UNITED STATES PATENT AND TRADEMARK OFFICE

APPLICATION NO.	FILING DATE	FIRST NAMED INVENTOR	ATTORNEY DOCKET NO.	CONFIRMATION NO.
10/073,770	02/11/2002	Tsuneo Watabe	CM-131	4514
24804	7590	08/26/2005	EXAMINER	
S.C. JOHNSON COMMERCIAL MARKETS INC 8310 16TH STREET, M/S 510 PO BOX 902 STURTEVANT, WI 53177-0902			MOHANDESI, JILA M	
			ART UNIT	PAPER NUMBER
			3728

Office Action Summary

FIG. 13

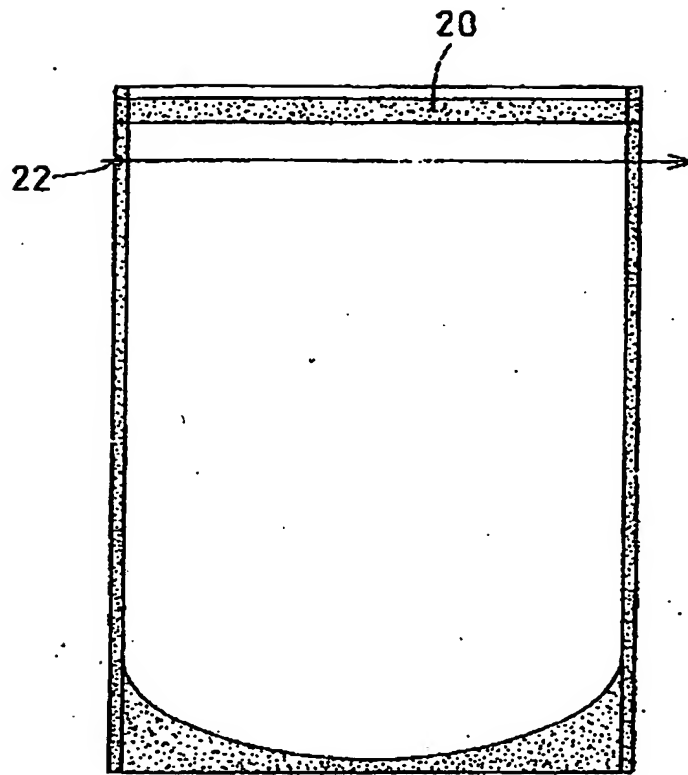
Please label Figures 13 and 14 with the legend "Prior Art". These figures are discussed in the "Description of the Related Art" section of the present application at page 3, lines 13 through 19. Each of these figures is referred to at lines 21 through 23 at page 15 in the specification as a "conventional example".

Substitute drawing sheets showing these changes are submitted herewith for the Examiner's approval.

Approved for entry.
In 08-15-05
